WETHERILL PARK

RESOURCE RECOVERY AND RECYCLING FACILITY
Response to Submissions

SSD 7401

Prepared for **Bettergrow Pty Ltd**

FIGURE 7: SURROUNDING RECEIVERS

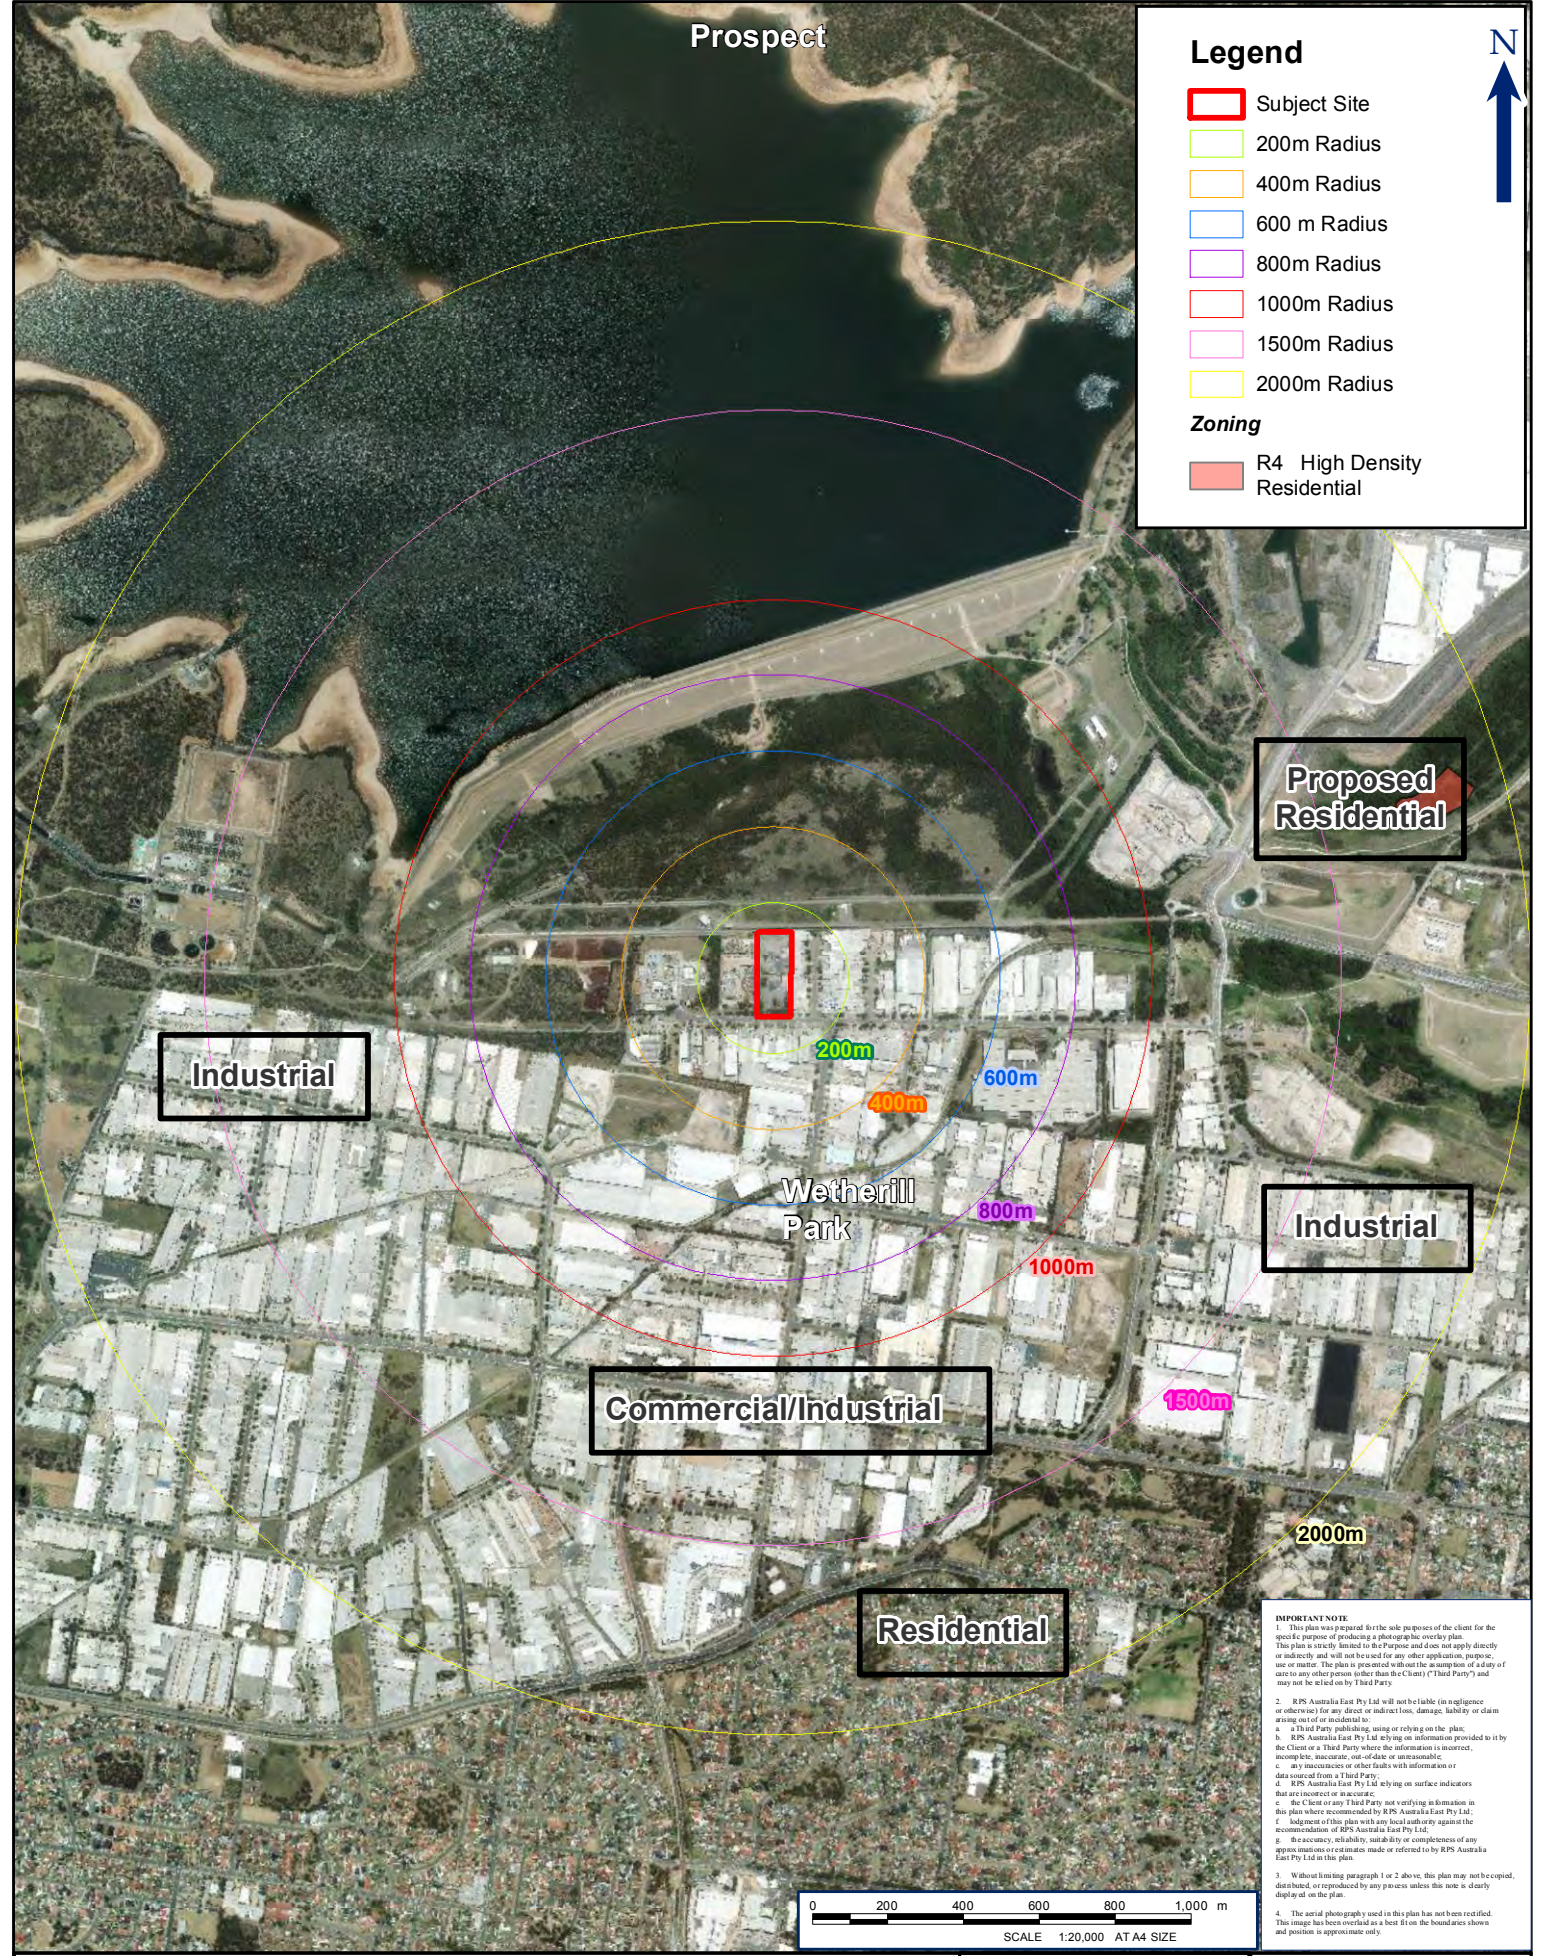
9. The Boral Widemere Resource Recovery Facility (SSD 6525), which was approved in November 2016, identified a future high density residential development to the east of the site. Please detail whether impacts on these future residents have been considered in the EIS

As this land is undeveloped at this point in time and would not be the closest residential receiver if it were developed, it has not been considered as part of the noise, odour, and dust modelling for the proposed facility. Further, noise, odour, and dust modelling show that this area is well outside the area of affectation.

Refer to **Appendix 2** for a revised **Figure 7** which shows the closest residential receivers, including the undeveloped R4 lands.

Figure 10: Location of Odorous Emission Sources

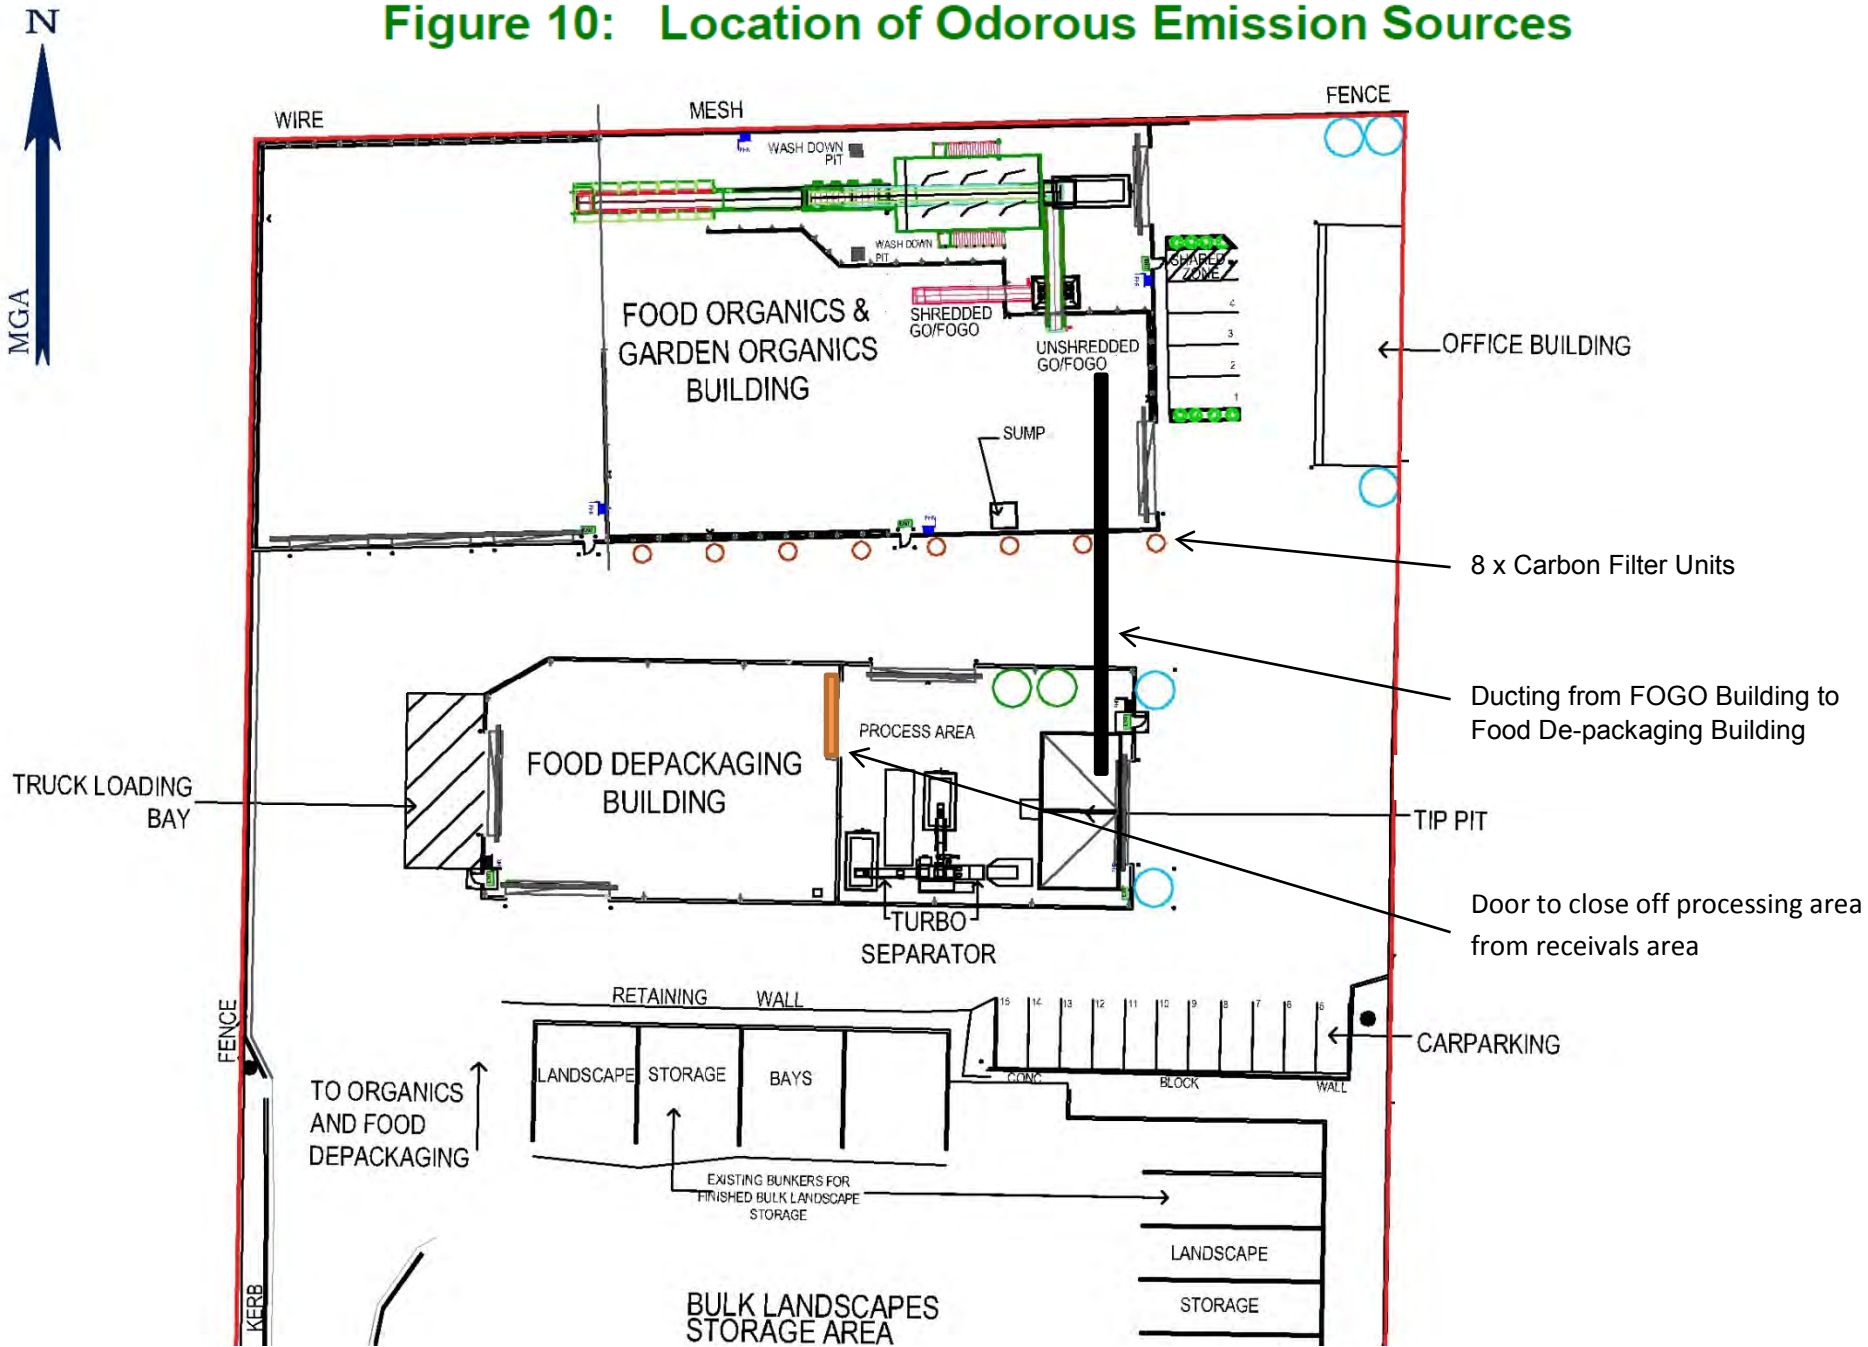
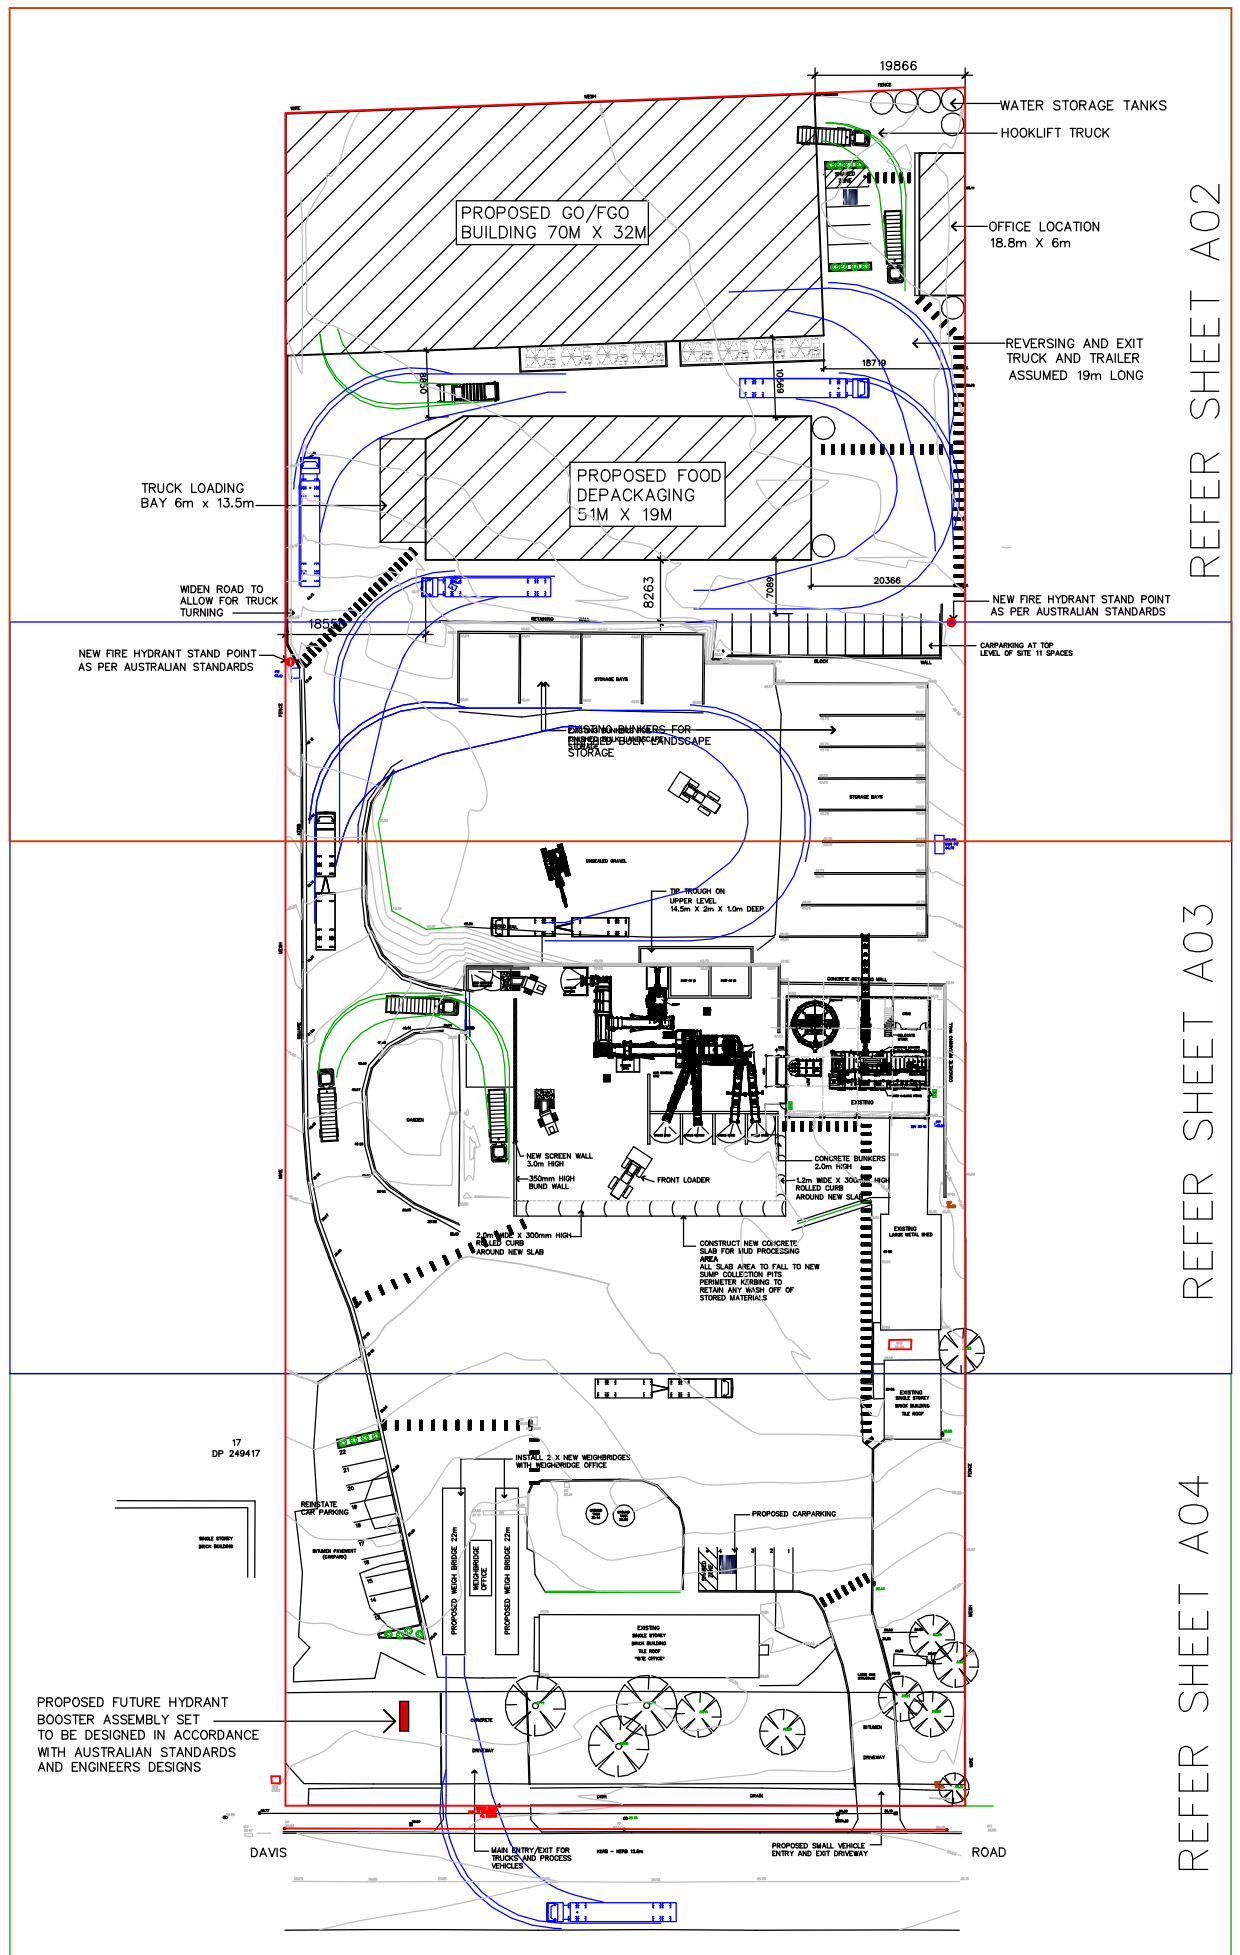
19. Figure 10 in the Odour Impact Assessment (OIA) (Appendix C of Appendix 8 of the EIS) is not legible. Please provide a legible figure

Figure 10 of Appendix C of the Odour Impact Assessment has been updated and is attached within **Appendix 2** of this report.
